STAFF REPORT: 2/23/2022 MEETING PREPARED BY: D. RIEDEN

**APPLICATION NUMBER:** #22-7657

VIOLATION NUMBER: #218 ADDRESS: 916 EDISON

**SCOPE:** RECONSTRUCT REAR PORTION OF HOUSE (WORK INITIATED)

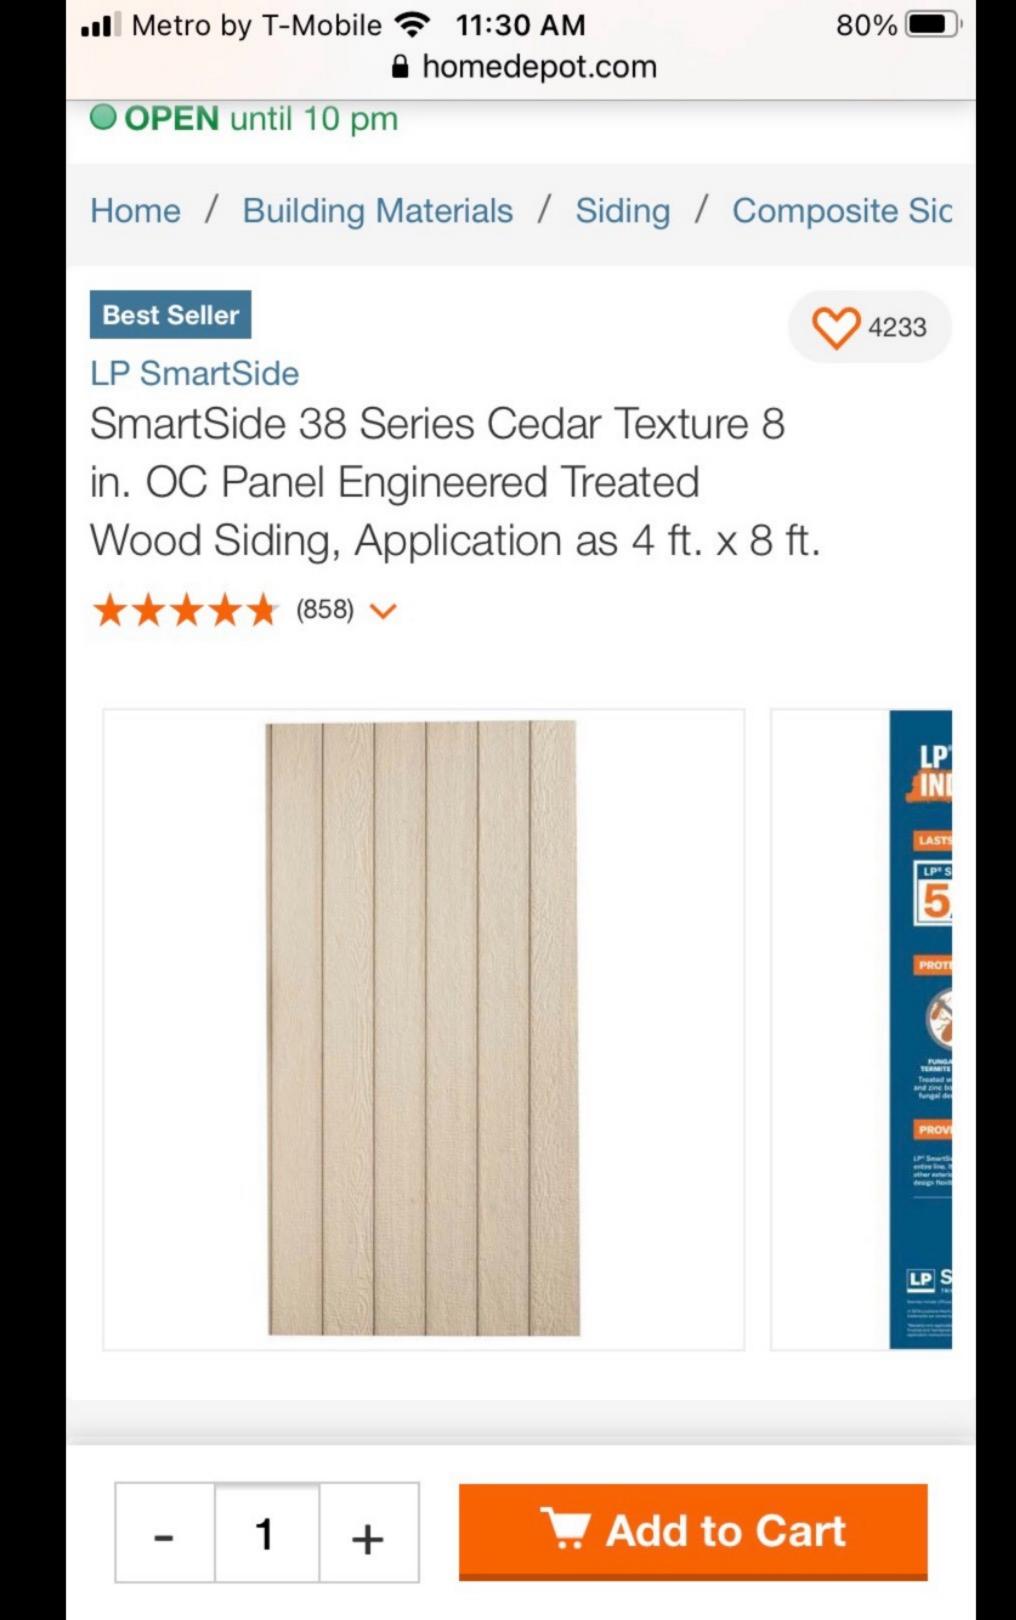
Would you please send us the dimensions on top of one of your photos or you can draw the dimensions and send us photo of your sketch with the dimensions of the addition in plan view. We do need to see this in feet and inches.

Here is some I will draw it out better I'm just trying to make sure you have what's needed to keep my appointment open for the 23rd
